Summary of Comments on window detail_ (003).pdf

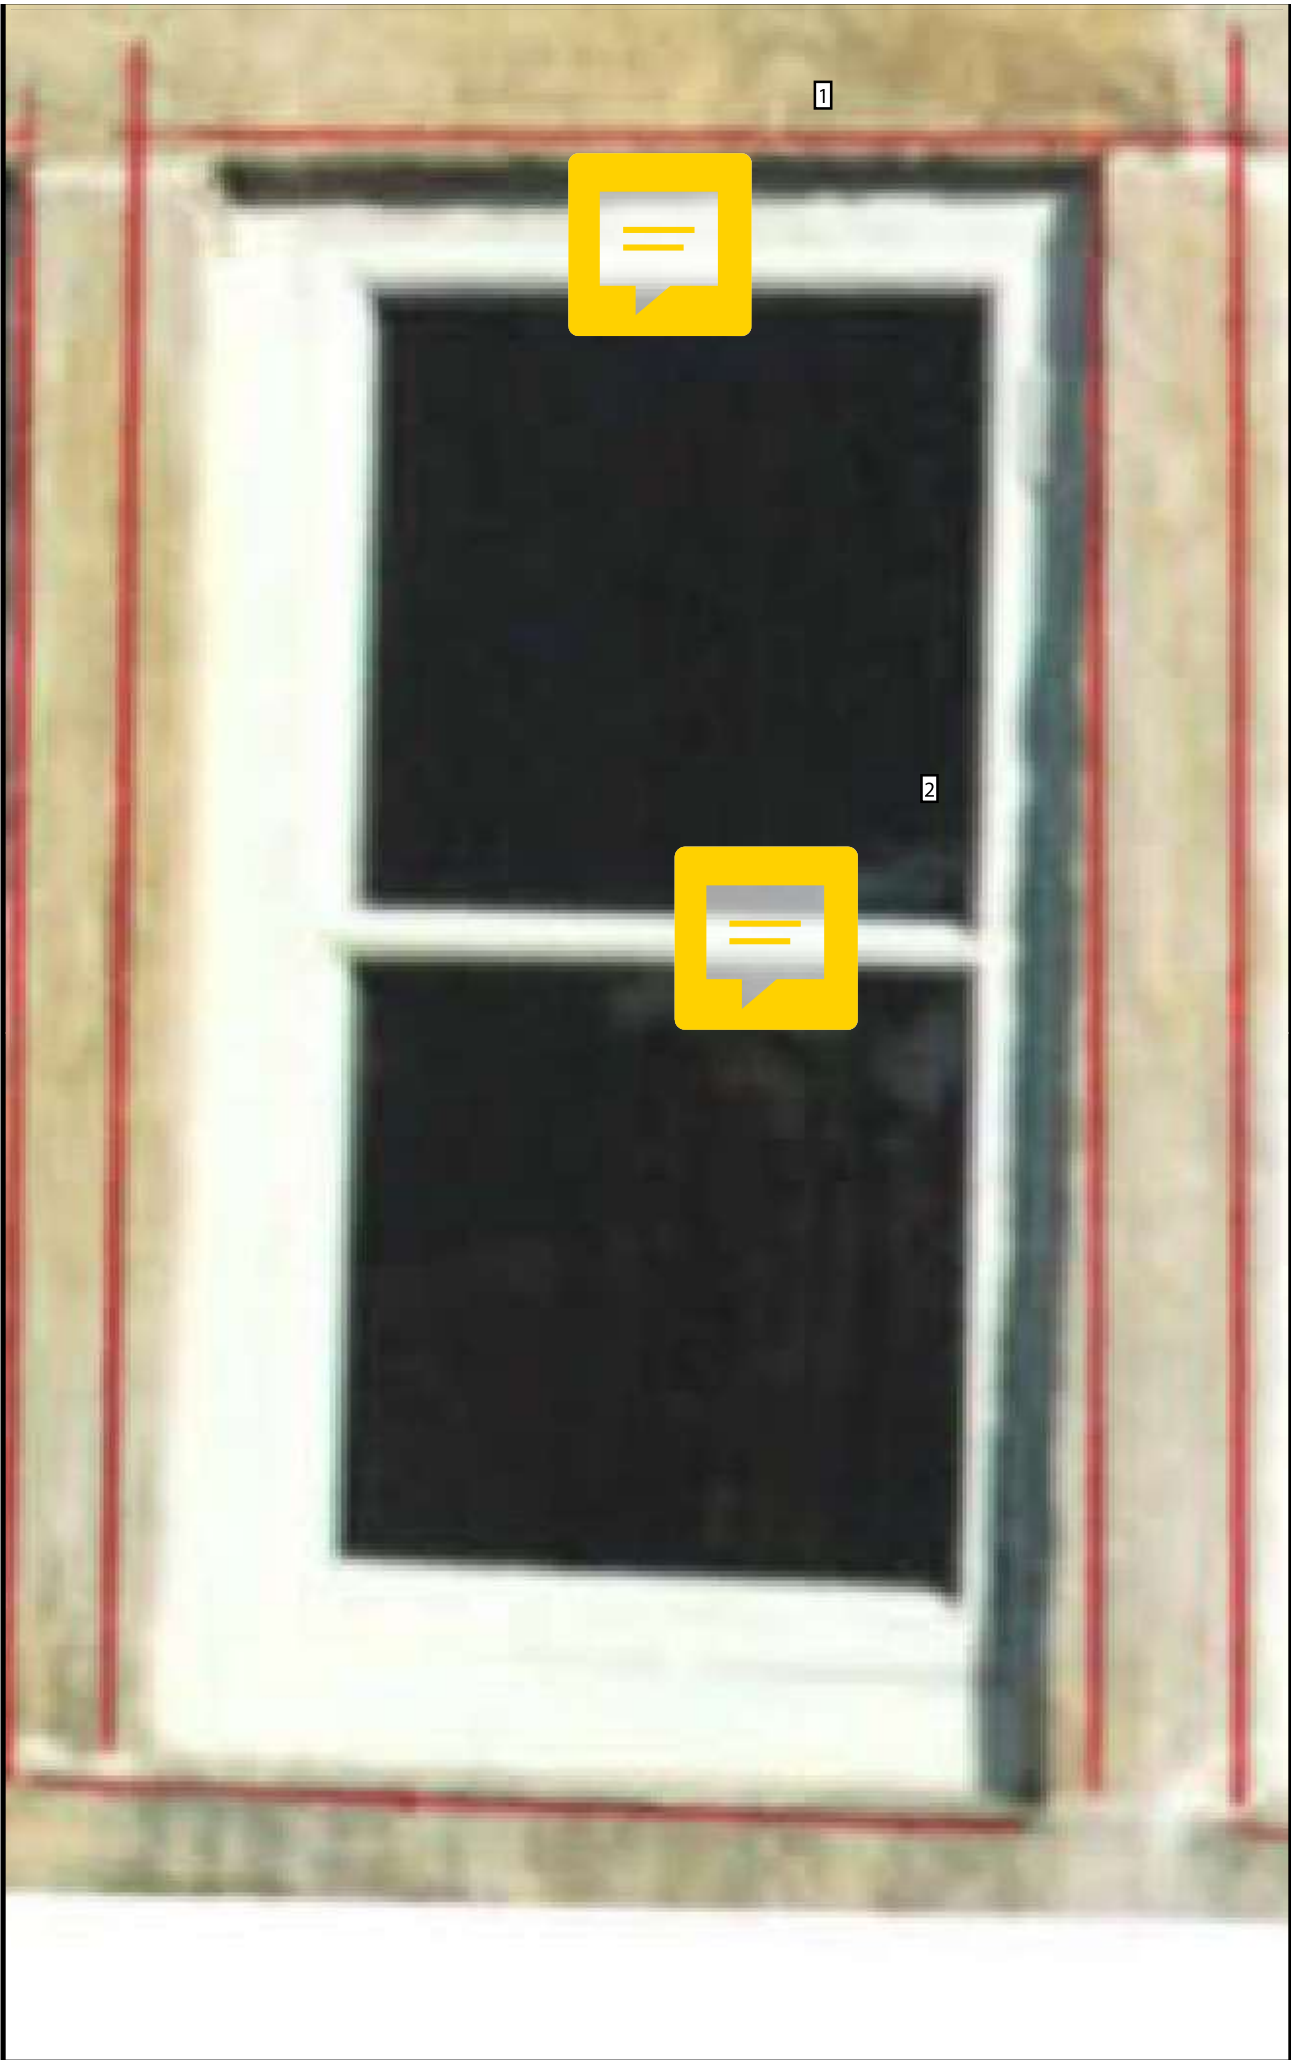
Number: 1	Author: FenghourCatherine	Subject: Sticky Note	Date: 03/10/2024 15:30:56
	please provide thickness			
	Author: 10660933	Subject: Sticky Note	Date: 08/10/2024 17:47:14	
	Frame size 80mm x 57mm			
	Sash size 44mm x 57mm			
	Number: 2	Author: FenghourCatherine	Subject: Sticky Note	Date: 03/10/2024 15:31:23
	please provide width and depth of glazing bar and confirm it will be integral			
	Author: 10660933	Subject: Sticky Note	Date: 08/10/2024 17:48:17	
	Glazing bar 38mm x 44 mm and is integral			
	Author: 10660933	Subject: Sticky Note	Date: 08/10/2024 17:48:39	
	Glass Units 14mm overall
